Australian Nursing Home
Foundation (ANHF)

ANHF Gordon

Acoustic review for Development
Application

Issue 2 | 11 October 2017

Figure 2: Lower Ground Floor Plan (Boffa Robertson)

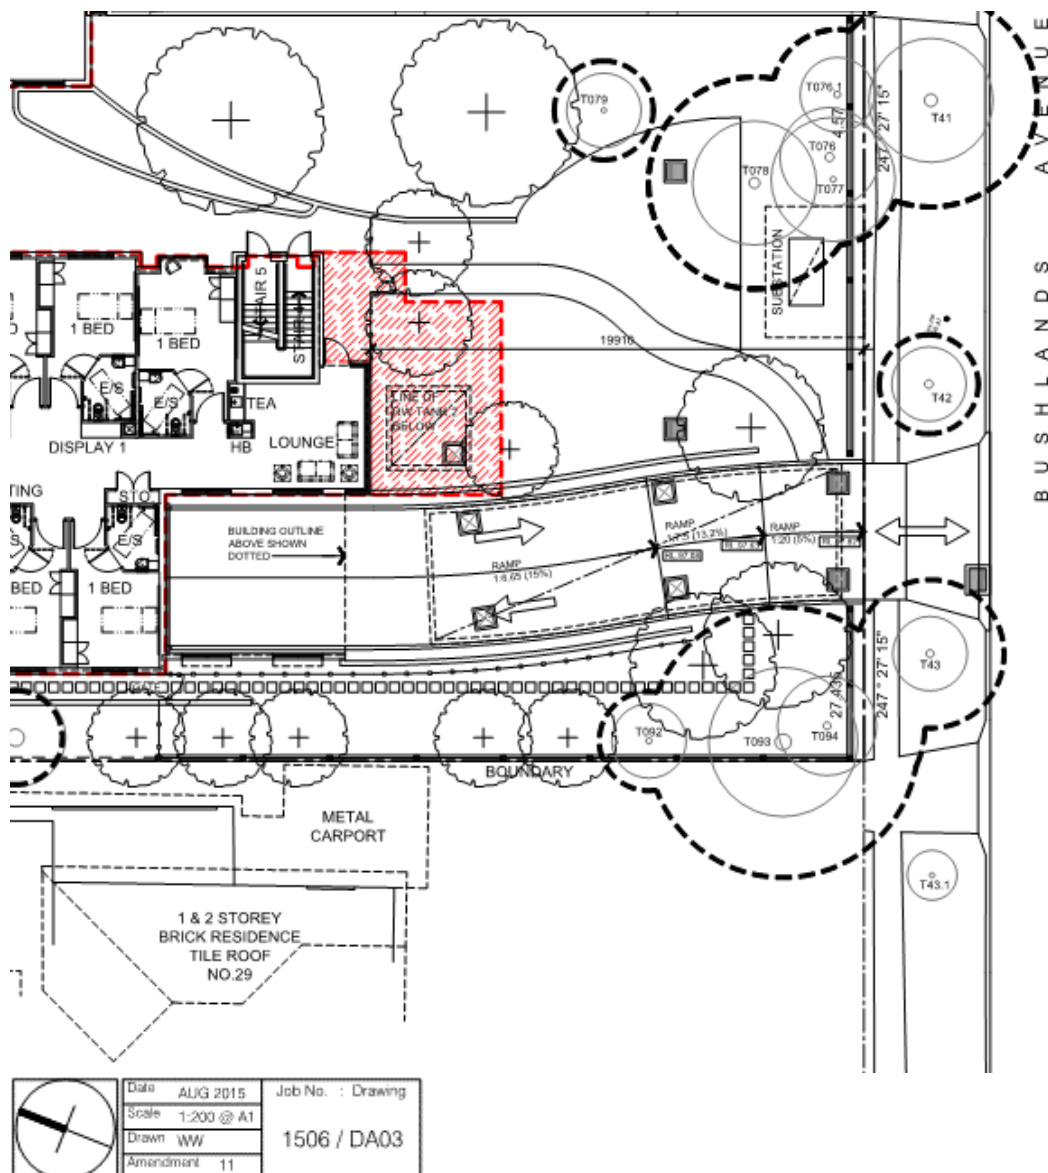
The ALC and TAG reports both sought clarification on the assessment carried out for vehicular movements on-site, which centres around light vehicle and community bus movements to and from the basement car park.

Access to the sites basement car park is proposed via a ramp at the western end of the site, neighbouring 29 Bushlands Avenue and opposite 32 Bushlands Avenue (see Figure 2).

- Noise predictions required to both 29 Bushlands Avenue and 32 Bushlands Avenue. While 29 Bushlands Avenue is in closer proximity, it is afforded some acoustic shielding from the ground level building envelope (over part of the ramp) and a 1.8 m high boundary fence, assumed to run along the full length of the western site boundary.

The assessment of vehicular movements indicate compliance with the intrusiveness criteria and upper level sleep disturbance criteria. The assessment however relies upon acoustic shielding provided by a barrier of 1.8 m high along

the western boundary of the site. It is possible however to reduce the height of the barrier at the front of the site to approximately 1.2 m for the first 3 m of the barrier. The barrier could alternatively be located at the edge of the drive way ramp, which could allow a reduction in its height, as it will be closer to the noise source (approximately 1.6 m at its highest point above the receiver ground level, also lowering at the front of the site).

Predictions indicate noise reduction of 7-8 dB(A) can be provided, though this relies on the fence being of sufficient mass, recommended to be no less than 15 kg/m². This can be achieved with a range of materials, including aerated concrete (ie Hebel), fibre-cement sheeting and/or polycarbonate. The construction and detailing of the fence shall be reviewed by an acoustic consultant during the design development and certified prior to issue of the construction certificate.

It is also recommended that acoustically absorptive treatment is installed to both sides of the retaining wall sections of the ramp, at least to the roller door alignment. Materials such as Pyrotek Reapor or Quietstone may be suitable due to being exposed to the environment locations. This design aspect should be reviewed further during the design development, to confirm material specifications and locations. This aspect shall be certified by an acoustic consultant prior to issue of the construction certificate.

Regarding the roller door, while not expected to be louder than bus movements, operation of door has the potential to impact on residents surrounding and within the facility if not appropriately designed and its use managed. In terms of design, slatted roller doors should be avoided and consideration should be given to a sectional overhead door. Motors will need to be appropriately specified or acoustically treated, inclusive of vibration isolation to minimise structure radiated noise to within the facility. Regarding operation of the door, it is understood that the door is to remain open during the daytime, however it is preferred to close during the evening and night period for additional security. Both the design and management of the car park security door shall be assessed and certified by an acoustic consultant prior to issue of the construction certificate.
